OPB LU 21-012886 DZM GW

Design Commission,

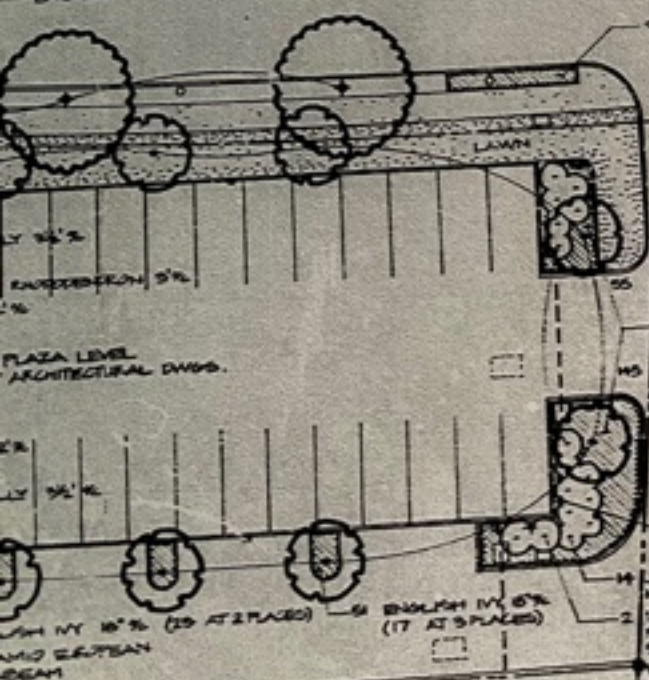
I strongly support moving the fence back 6' from the sidewalk as OPB proposes along the east several feet of the south fence. BUT it would be SAFER if the angle were changed so that the southeast corner were set back about 8' instead of 6'. That would greatly improve sightlines between rail vehicle operators and bikers and walkers emerging from behind the fence to cross. Moving the corner back 2' would mean rail operators and crossers would see each other when the rail vehicle was dozens of feet further away, due to the angle of the sightlines.

The fence was approved in 1987 to be set back several feet the entire length of the south fence along the sidewalk. OPB built it up against the sidewalk in violation of that approved site plan. **I've attached that plan along with photos previously submitted showing how the current fence totally blocks sightlines between rail operators and rail crossers. You can also see how moving the southeast corner an additional 2' north from the 6' proposed would improve sightlines while still keeping the fence well away from any satellite.**
